POSITION STATEMENT ON INDIAN POINT UNIT 3

PLANT NAME: Indian Point Unit 3

DOCKET NO.: 50-286

INDIAN POINT #3 LOCA DOSES - STATUS REPORT

0-2 HOUR THYROID DOSES BASED ON PASQUILL "F", $\bar{u} = 0.7 \text{ M/SEC}$
 INDIAN POINT # 3

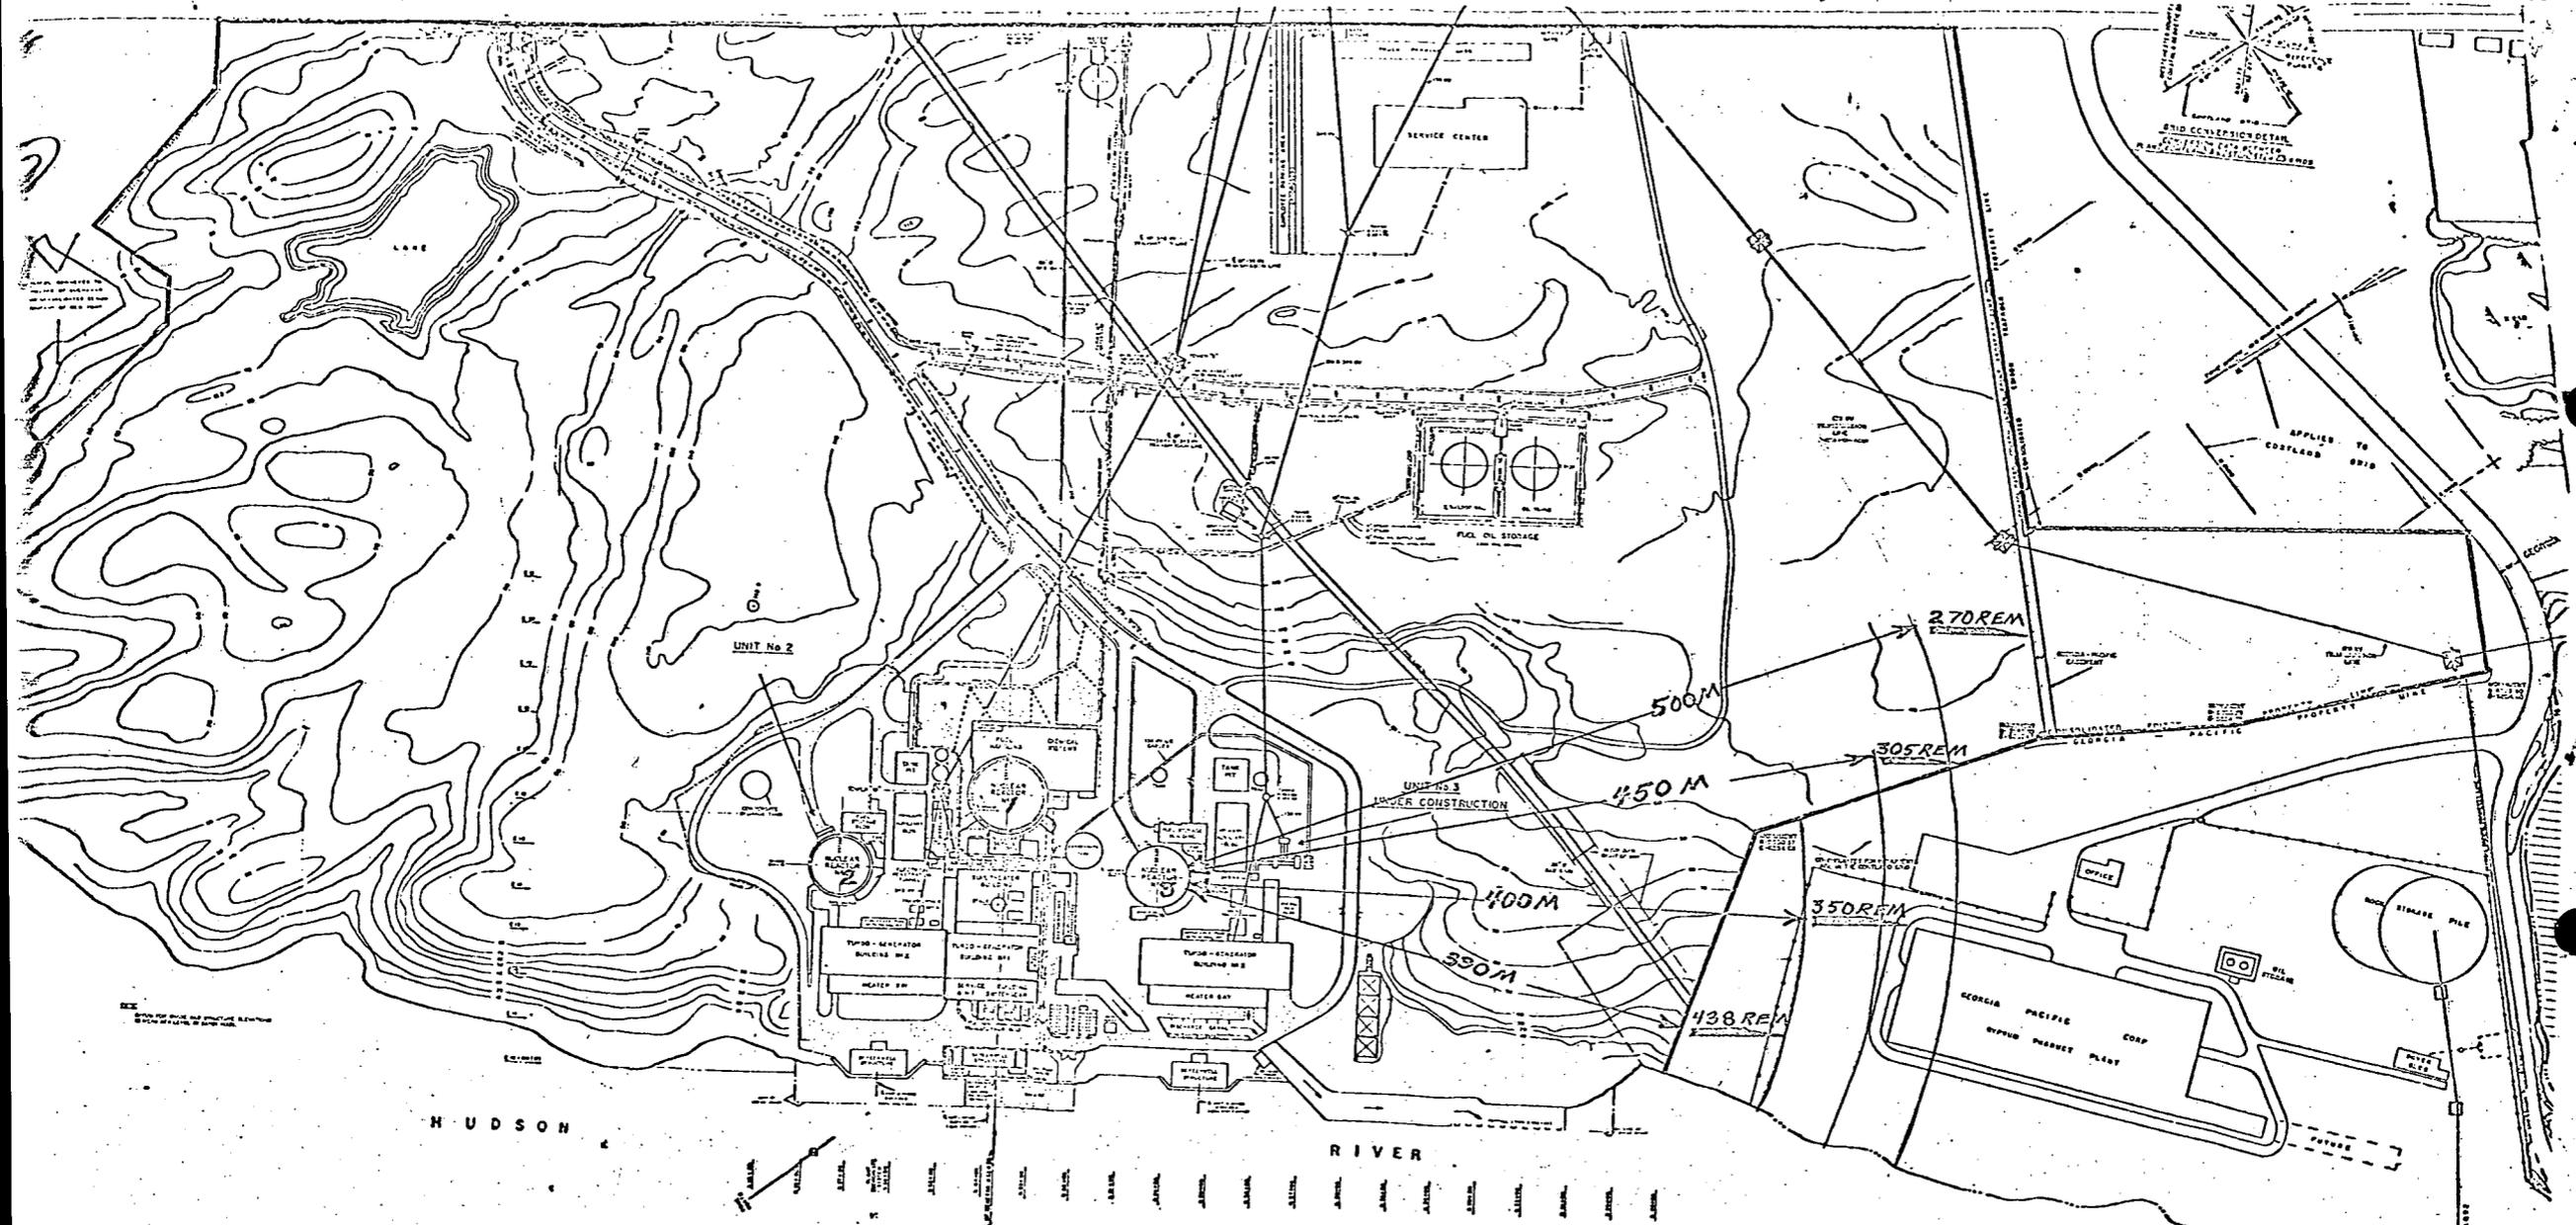
done in the case of the Zimmer facility (Docket No. 50-358). This is illustrated by the enclosed figure which indicates LOCA 0-2 hour thyroid doses as a function of distance.

Unit 3 is roughly a duplicate of Unit 2 except that the minimum distance to the site boundary is 330 meters rather than 530 meters. The minimum distance for Unit 3 is toward the southwest boundary which borders the Georgia-Pacific Corp. gypsum product plant. One way of meeting the Part 100 guidelines would be for the applicant to obtain an easement granting emergency control over a portion of the Georgia-Pacific property as was

We recommend that this matter be again brought to the applicant's attention, with an indication that an adequate solution cannot be further delayed without consequence to the review schedule.
